Re: DEL-AIR LODGE REDEVELOPMENT
Substantial Performance

Date: **June 17th, 2024** JMAA Job # 1264-20 **Substantial Inspection**
Number of Pages (8)

Re: **JMAA Substantial Inspection – June 13th, 2024**

PROJECT NAME:	Del Air Lodge Redevelopment	PROJECT NO.:	21-086
ISSUED BY:	DOUG MACDONALD	DATE OF ISSUE:	JUNE 18, 2024
		DATE OF REVIEW:	JUNE 13, 2024

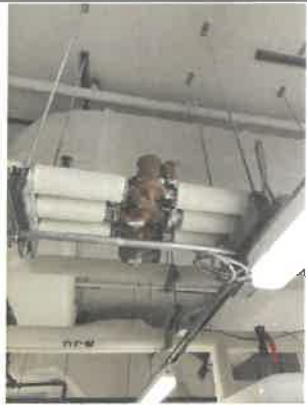
<p>3.5</p>	<p>Within the walk in coolers, the sprinkler heads are at low level and above shelving. It is recommended that sprinkler head protection in the form of a wire cage be installed anywhere that sprinkler heads are at risk of being hit.</p>		<p>Deficient</p>
<p>3.6</p>	<p>Within the walk in coolers, the sprinkler heads are at low level and above shelving. It is recommended that sprinkler head protection in the form of a wire cage be installed anywhere that sprinkler heads are at risk of being hit.</p>		<p>Deficient</p>
